Addendum No.2
to
CONSTRUCTION DOCUMENTS
for

June 2, 2025
2023159.00

NCISD New District Administration Building
21330 Valley Ranch Parkway
New Caney, TX. 77357
June 2, 2025

A-159

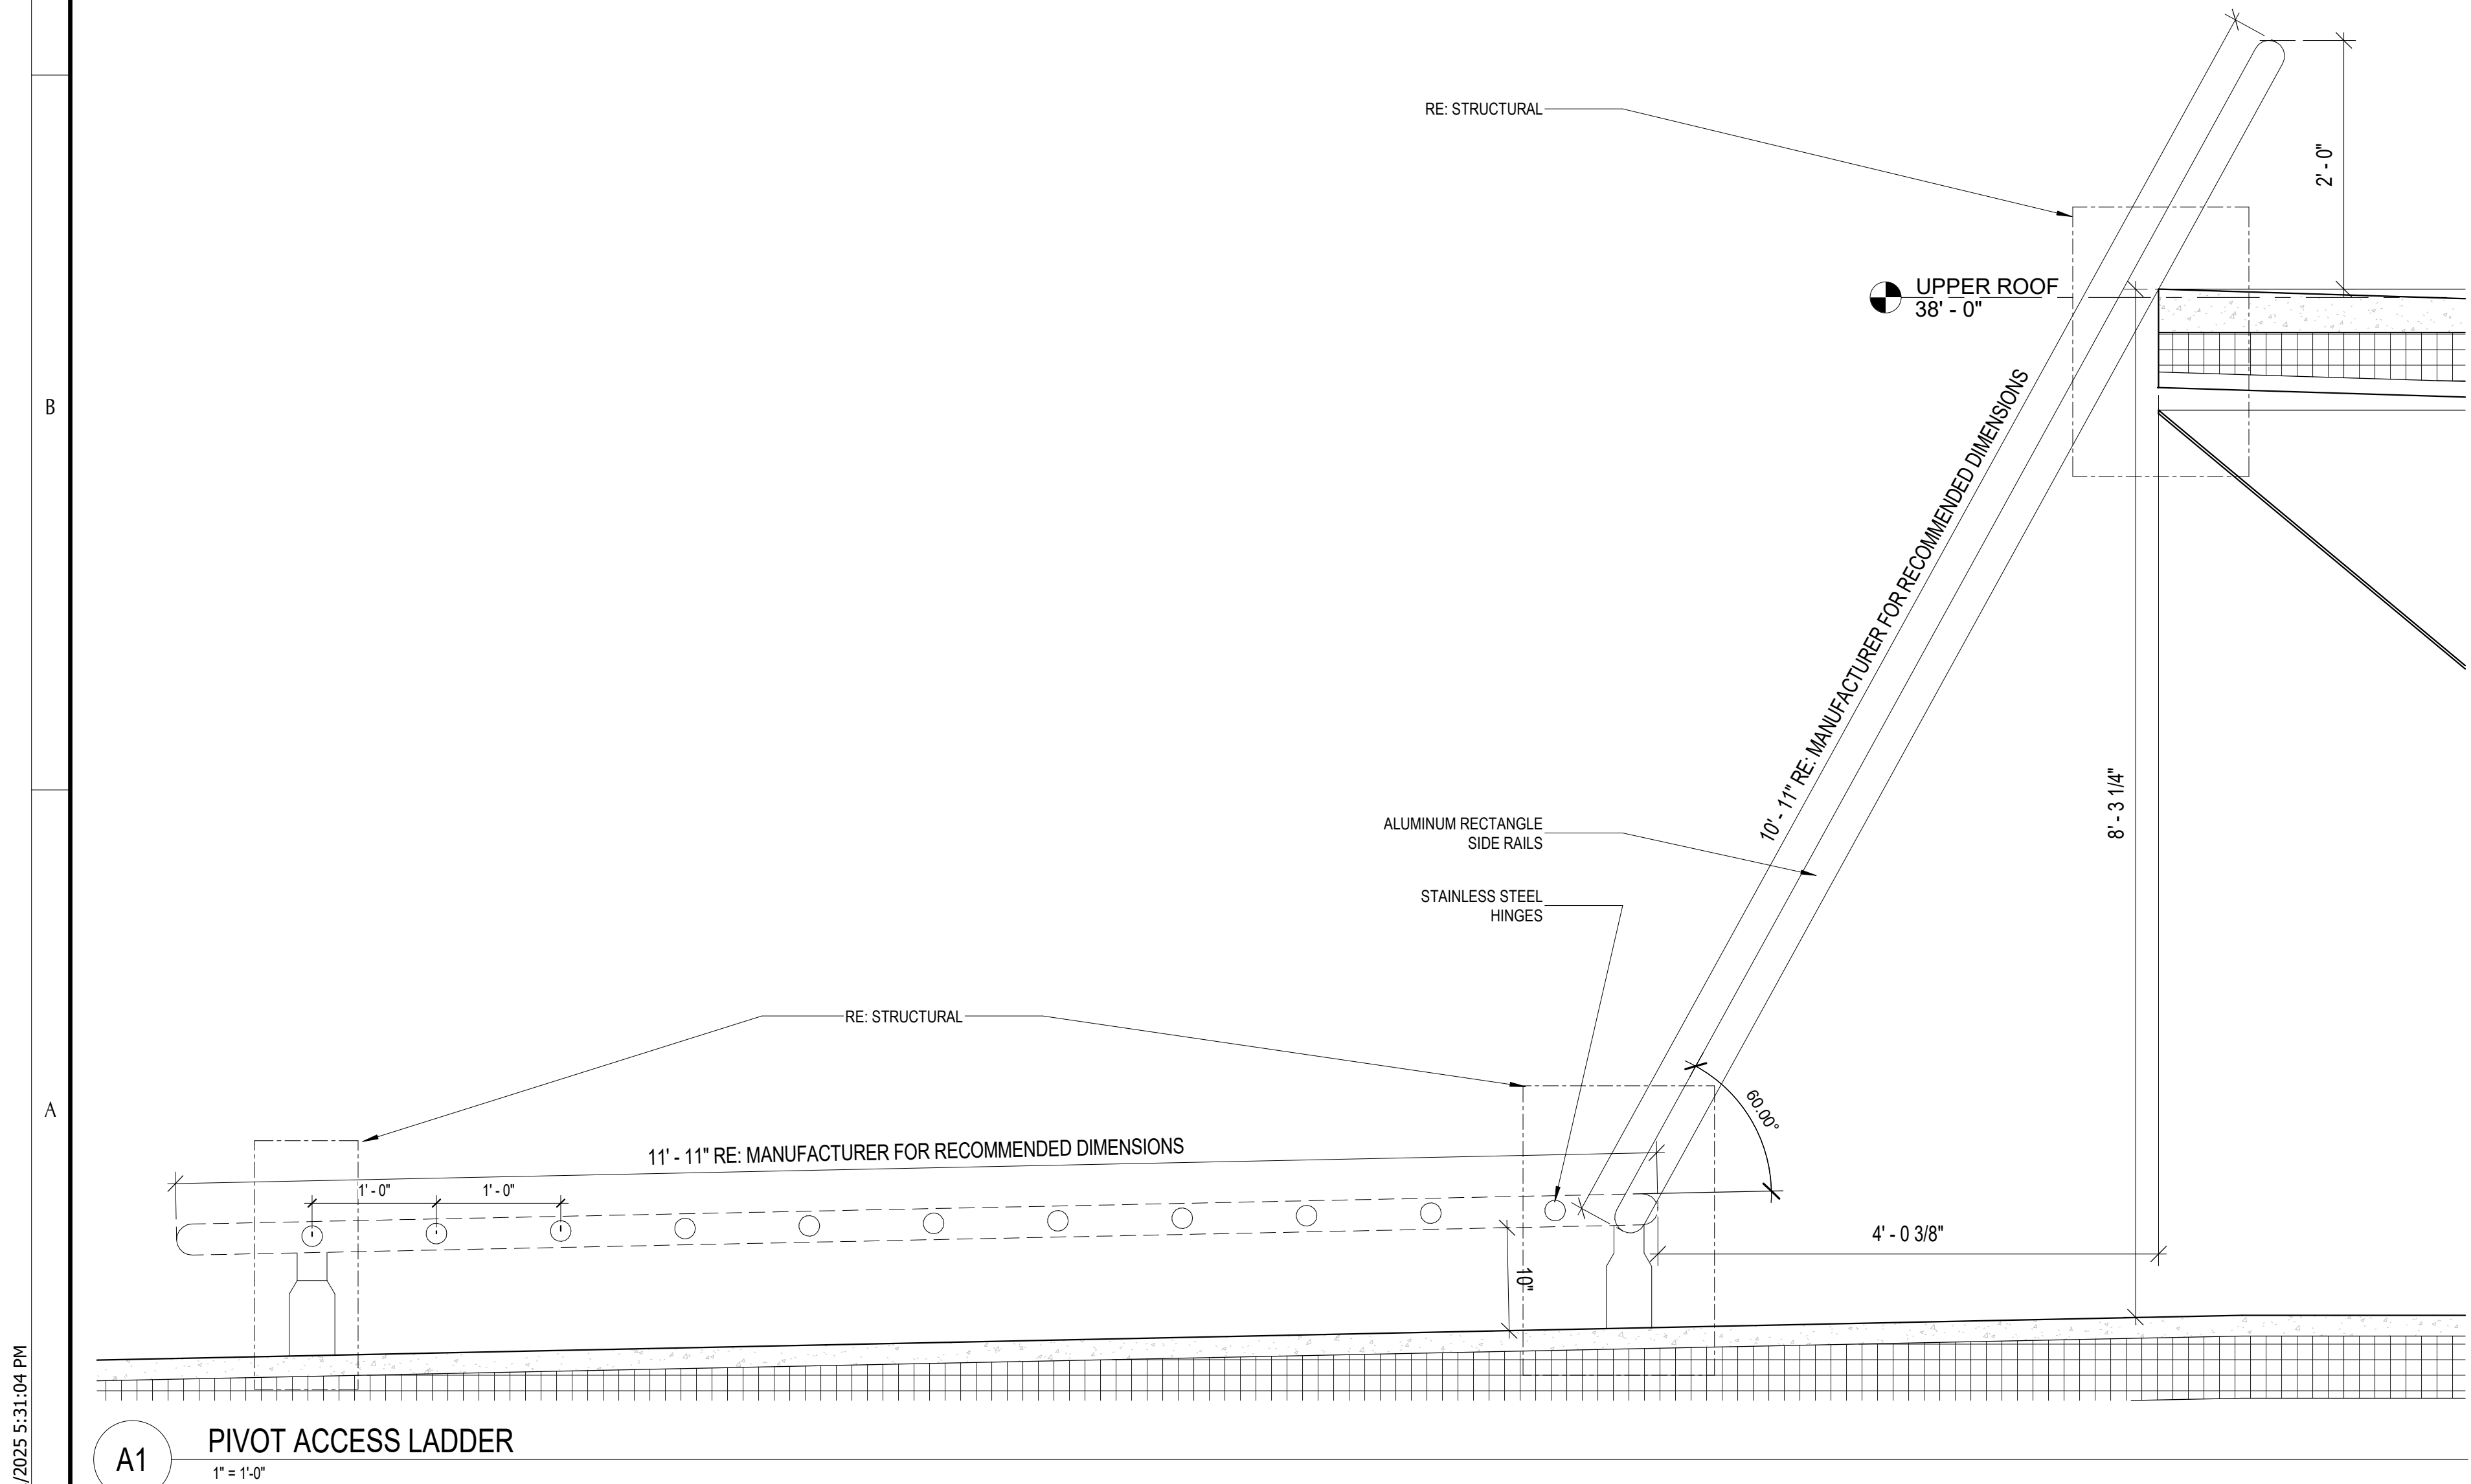
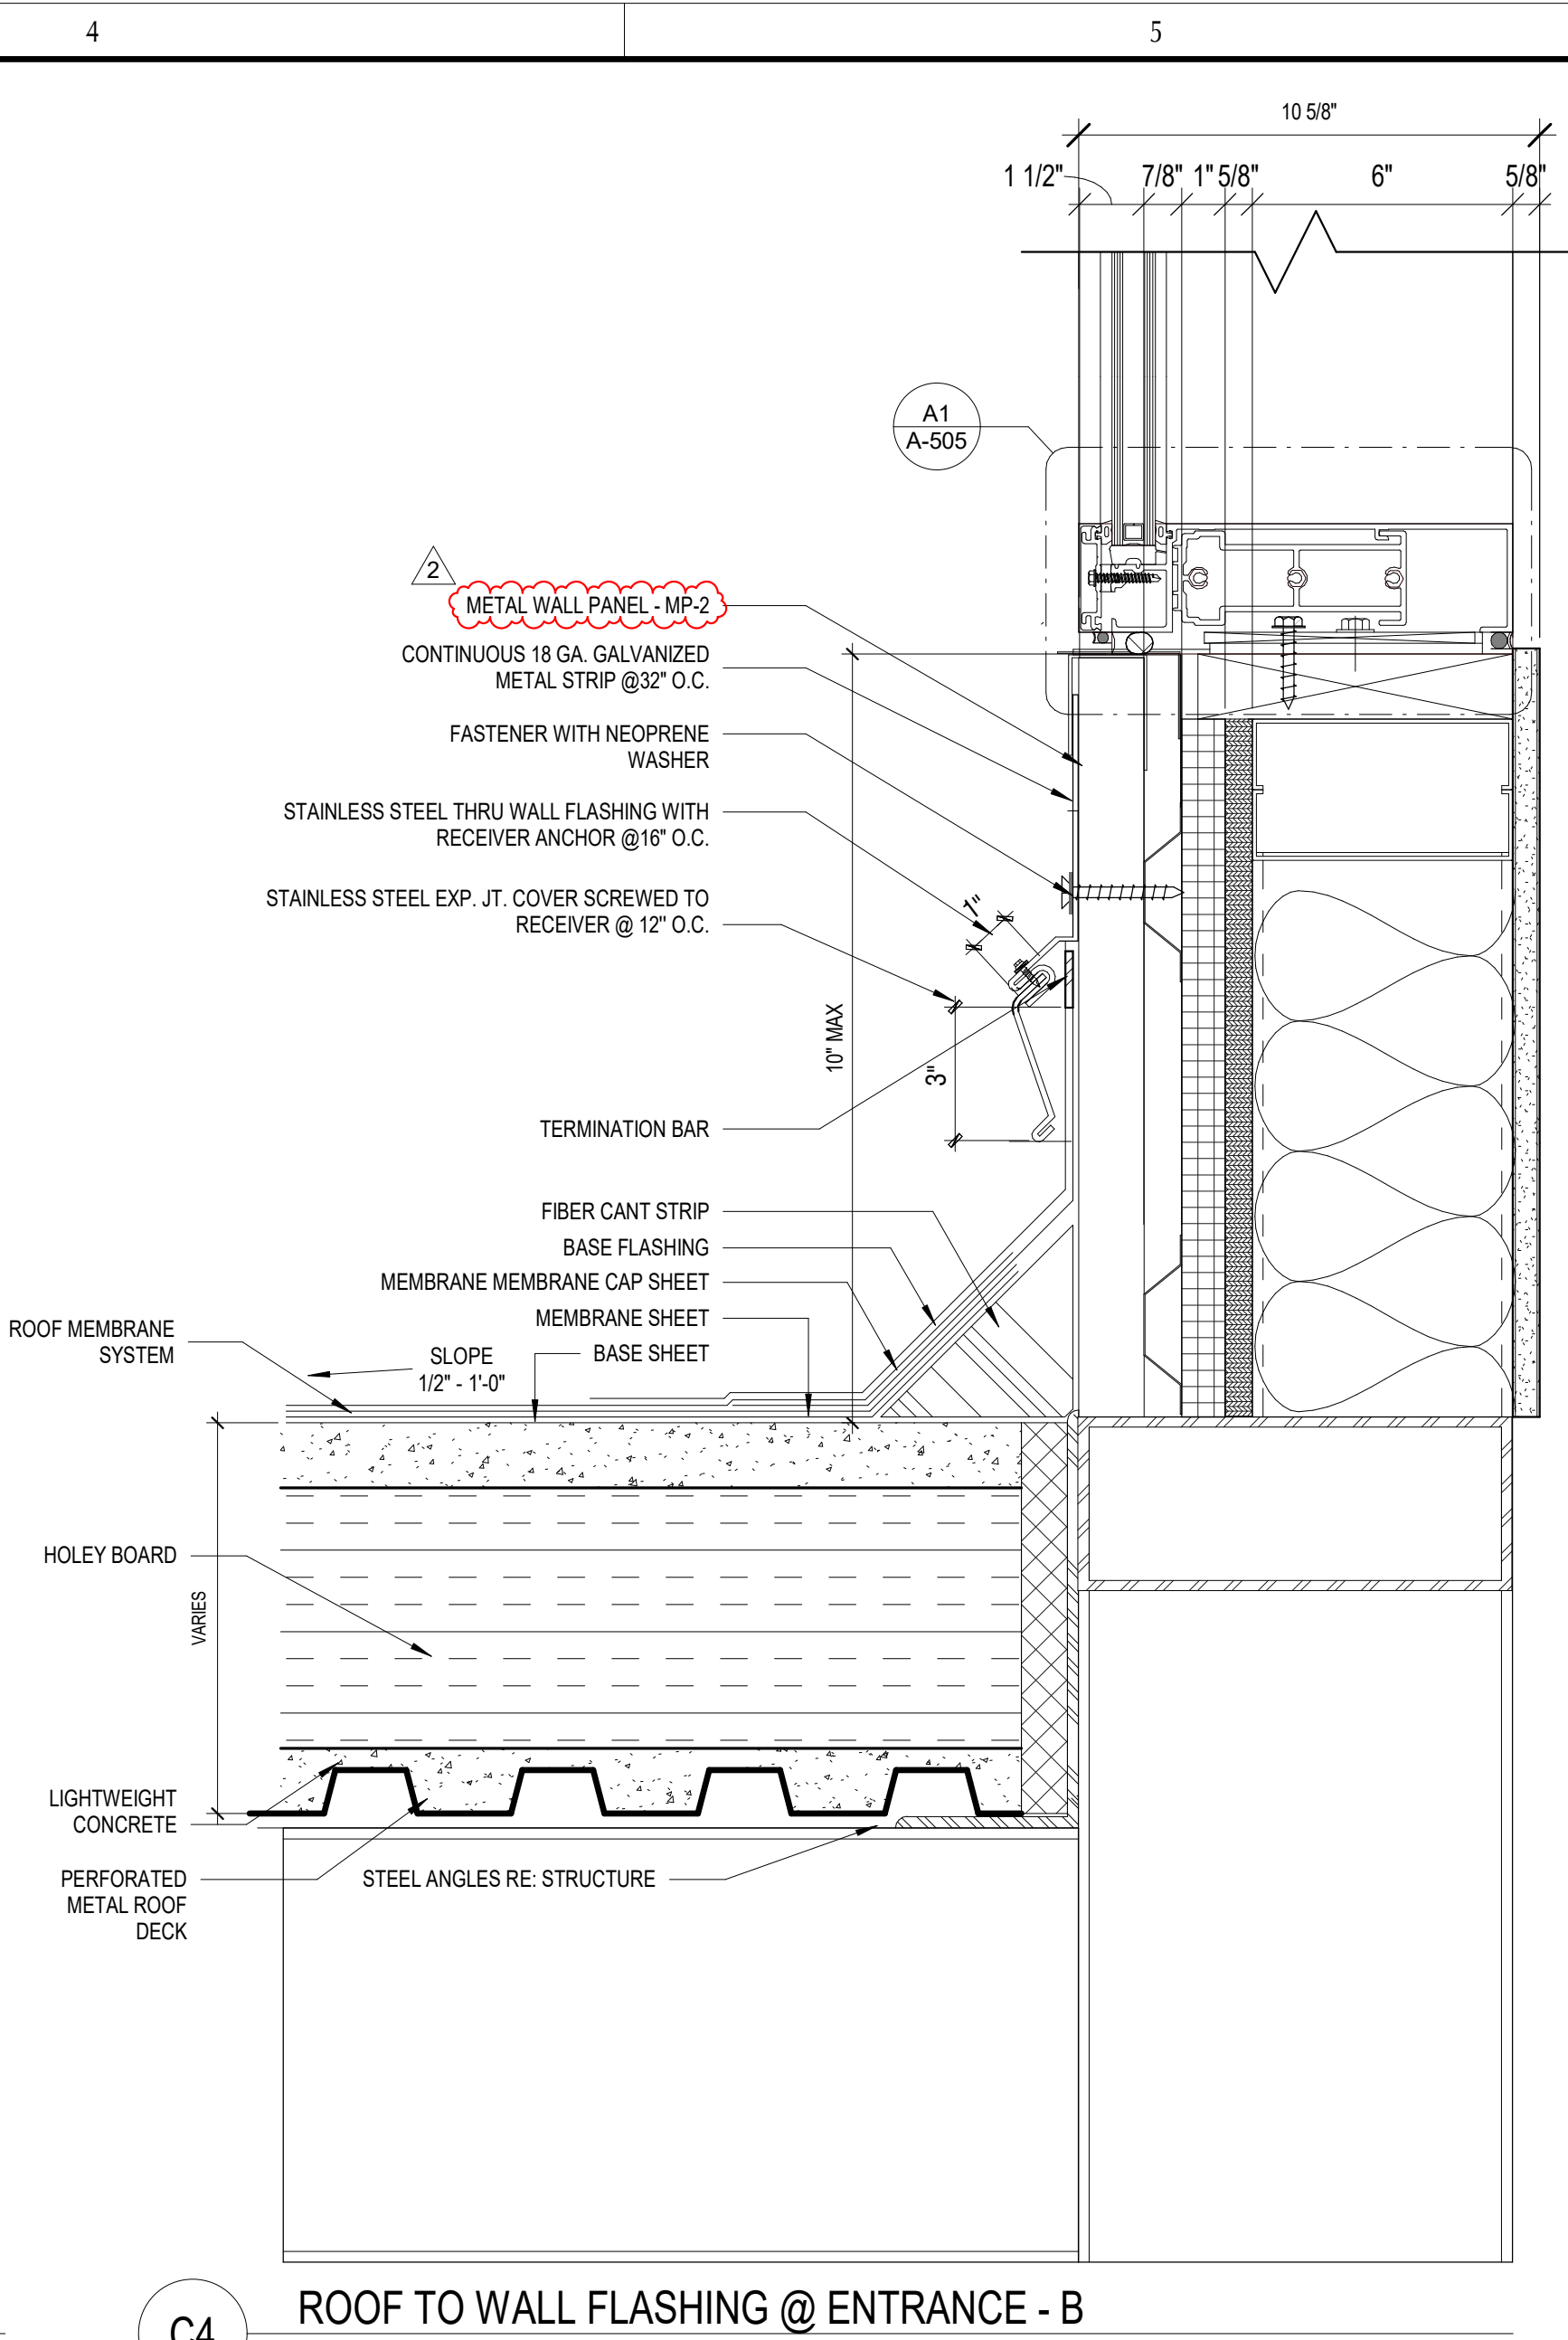
27. Sheet A-159 – Roof Details
- a. Refer to revised details A4, A6, and C4.
28. Sheet A-201 – Exterior Elevations
- a. Notes revised on all elevations.
 - b. Exterior finish schedule updated to show BRK-1 and BRK-2.
